Minutes – Executive Policy Committee – January 22, 2019

Item No. 5 Subdivision and Rezoning – 1493 Magnus Avenue (Point Douglas Ward) File DASZ 9/2018 [c/r DAV 125313/2018D]

Title: DASZ 9/2018 – 1493 Magnus Ave

Issue: An application for consideration at the Public Hearing to rezone an existing "R1-M" residential single-family zoning district to an "RMF-S" Residential Multi-Family (Small) zoning district, consolidate all underlying lots and construct a townhouse development.

Schedule "A" for File No. DASZ 9/2018, Lord Selkirk – West KIldonan Community Committee, dated May 8, 2018

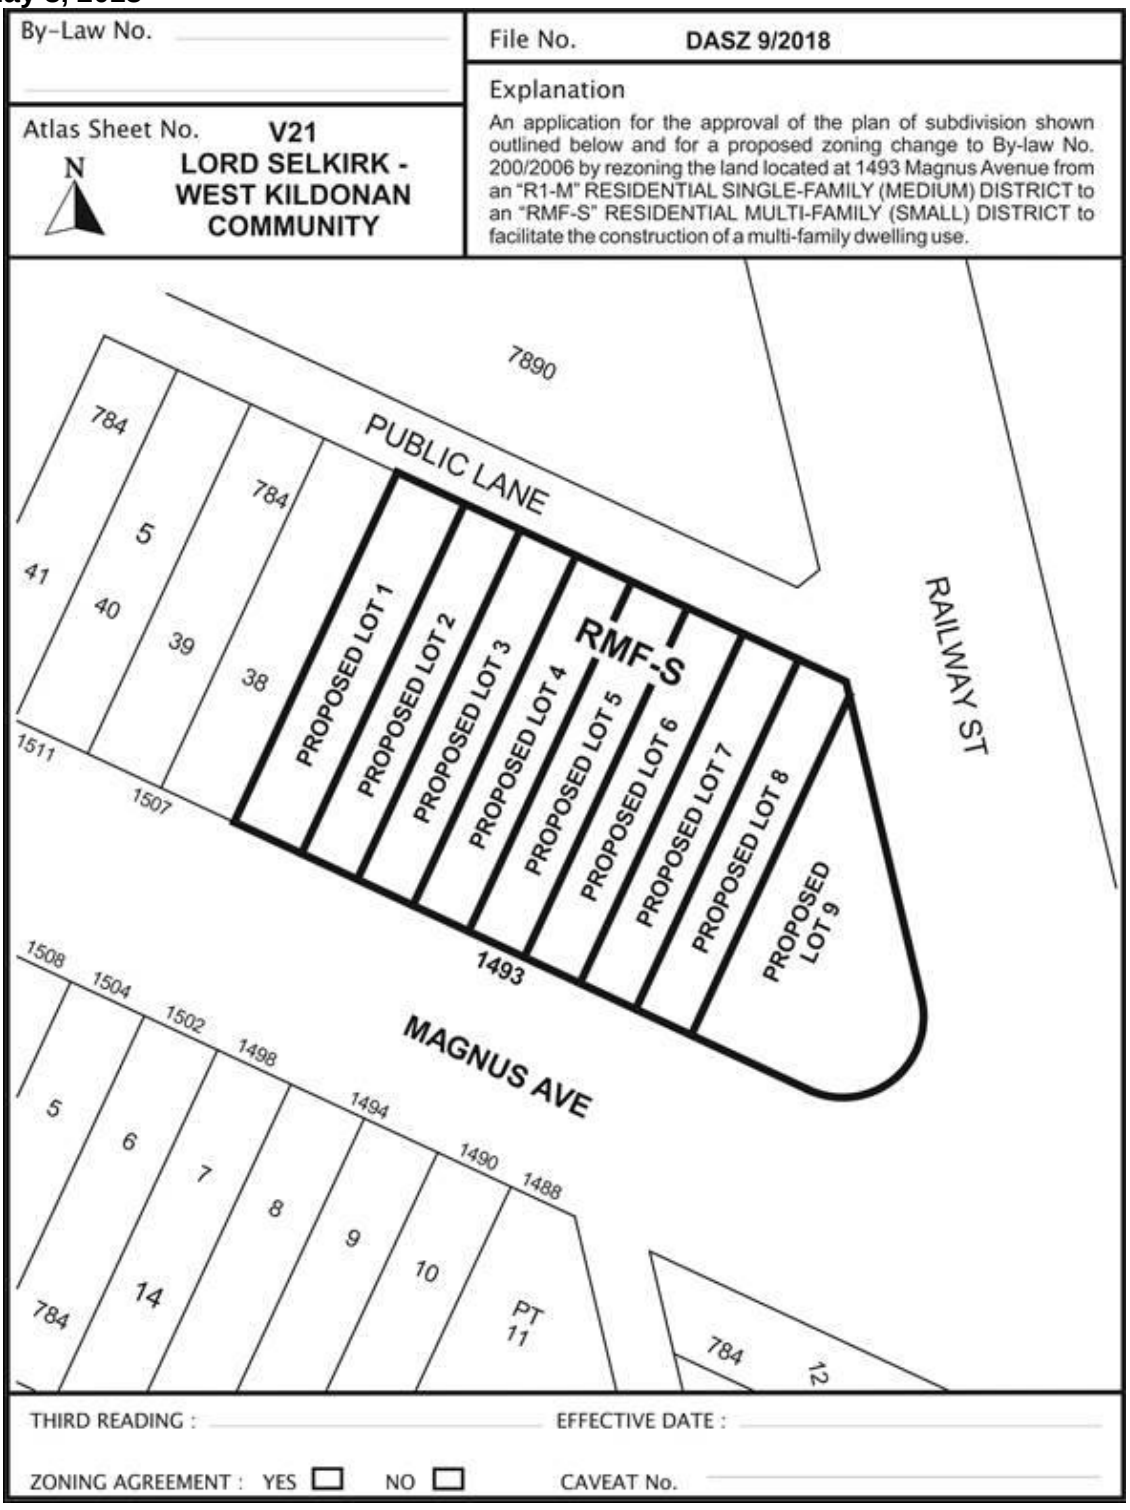
- However, there are aspects of the design of the proposed use that are inconsistent and incompatible with the existing character of the neighbourhood. Specifically, the site plan illustrates a private approach gaining access to proposed unit #9 from Magnus Ave. Given that the property is served by a public lane, the expectation is that all vehicular access to the site must be from the public lane. The Public Service believes there are alternatives to the design of the site to avoid the need for any approaches onto existing streets abutting the site. The length of the lane providing direct access to the subject site is approximately 150 feet which provides ample opportunity for site access.

- Given this situation, the Public Service recommends that proposed Lot 9 be amalgamated with Proposed Lot 8 to alleviate site access issues. To this end, a new Schedule (Schedule “D”) has been created and appended to this report and it is recommended it replace Schedule “A, the subdivision plan submitted by the applicant.

Schedule "B" for File No. DASZ 9/2018, Lord Selkirk – West Kildonan Community Committee, dated August 20, 2018

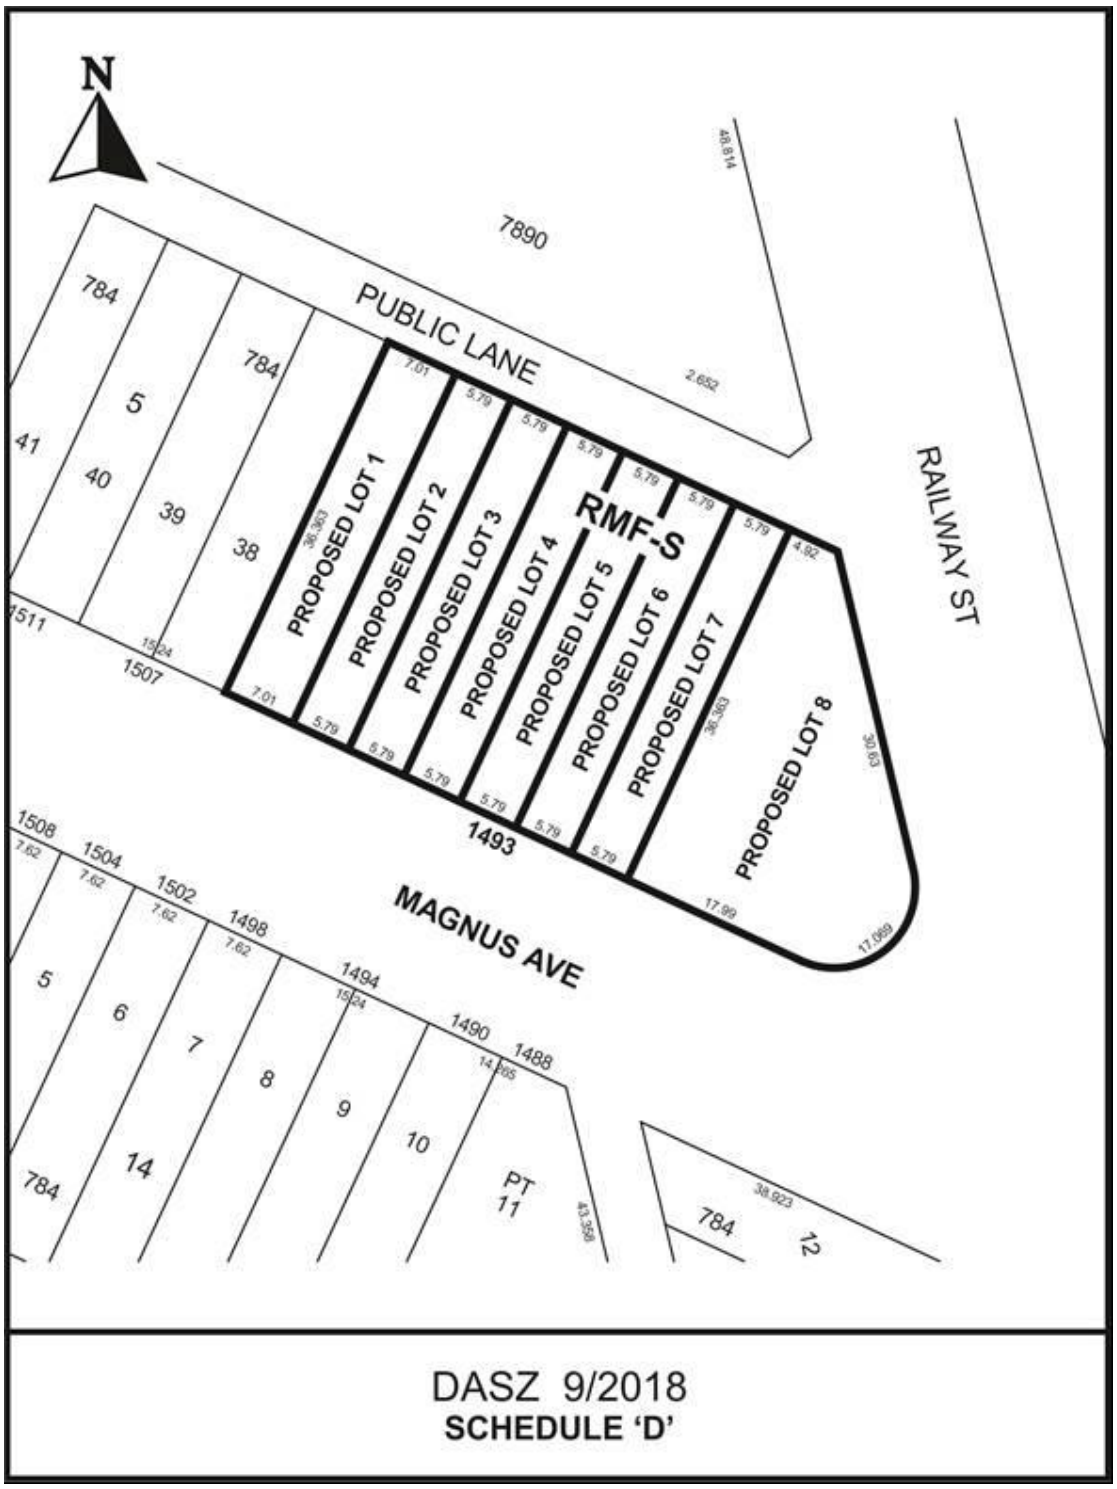
- *Reduced berm heights are possible where larger setbacks are proposed.*
- It is noted that the proponent's site plan does not adhere to the above standards. The applicant is aware of the concerns of the Public Service and Council direction, but wishes not to construct the berm. Instead of rejecting the application altogether, the Urban Planning Division is recommending the above requirements be stated in recommended zoning agreement for this application.

- The Division believes the site plan can be modified in a number of ways to meet the *Federation of Canadian Municipalities "best practices"*. For example, if the proposed unit on Lot 8 remains in the same place under the recommended approval of Schedule 'D', the required berm on Proposed Lot 8 could easily be accommodated within the site due to the increased setback of the dwelling from the CPR Arborg Subdivision.

- Per recommended condition 2.A.(ii)(d) of the zoning agreement, the berm height can be reduced if the setback is increased. The subject site is separated from the CPR Arborg Subdivision by Railway Street (which is +/-65 feet wide), and the site plans submitted show that the dwelling on Lot 8 is approximately 45 feet from the eastern property line.

- Given a setback of at least 110 feet (33.5 metres), and using the calculation provided in recommended condition 2.A.(ii)(d) of the zoning agreement, the berm height along the eastern property line of Proposed Lot 8 in Schedule 'D' would be 0.9 metres tall. When calculating the required side slopes per recommended condition 2.A.(ii)(a) of the zoning agreement, approximately 20 feet of property would be required to accommodate the 0.9

metre tall berm. This means that proposed unit 8 would be located approximately 25 feet away from the nearest point of the berm.

2. That The Winnipeg Zoning By-law No. 200/06 be amended by rezoning the subject land as shown on Schedule "B" for File DASZ 9/2018 dated August 20, 2018, to an "RMF-S" Residential Multi-Family (Small) District subject to the following conditions:

i. There shall be no private approaches granted on Railway Street or Magnus Avenue

ii. That, the developer shall, at no expense to the City, provide safety measures from the CPR Arborg Subdivision consisting of the following:

a. A minimum setback of 15 metres to any portion of a habitable room or space within a building located on the Developer's land, measured from the western property line of the CPR Arborg Subdivision.

b. A 2.0 metre in height uniform noise attenuation fence be built to the satisfaction of the Director of Planning, Property, and Development.
